Machine	TASKI swingo 350
Subassembly	Charger

Spare part set charger

GTS Newsletter

2017 / 04E

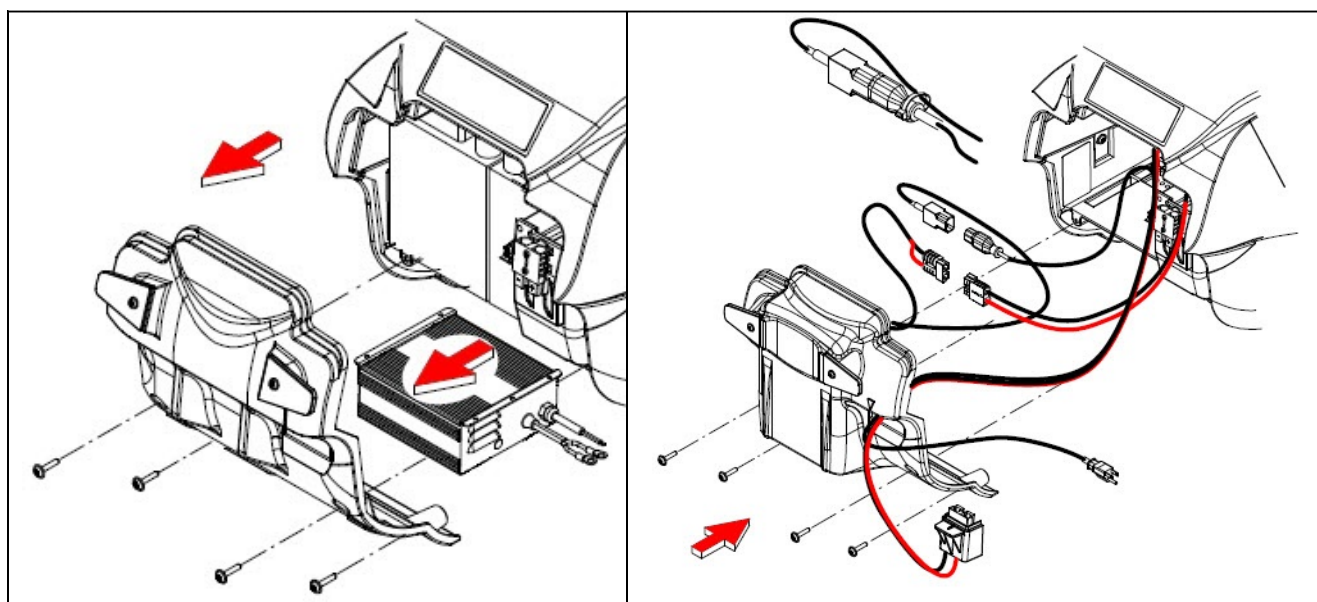
Due to a high rate of failures of the 5A charger in the field we have prepared a spare part set for older TASKI swingo 350B. Besides the charger, it includes a rear cover panel as well as two adaptor cables and the corresponding mounting material. Also a mounting instruction is in the set.

Important is after replacing the old 5A Charger to check if the setting of the charging curve is the appropriate one. This can be done by using the DIP-switches, which are located underneath the stopple. Preset ex-factory is always the GEL-curve.

The main cord is NOT included. This has to be ordered separately. Caution: For the new charger a 3-pole main cord has to be ordered as it is a protection class 1 device.

Description	Material number	Remarks
Charger set	4132834 (17422-23)	New spare part number
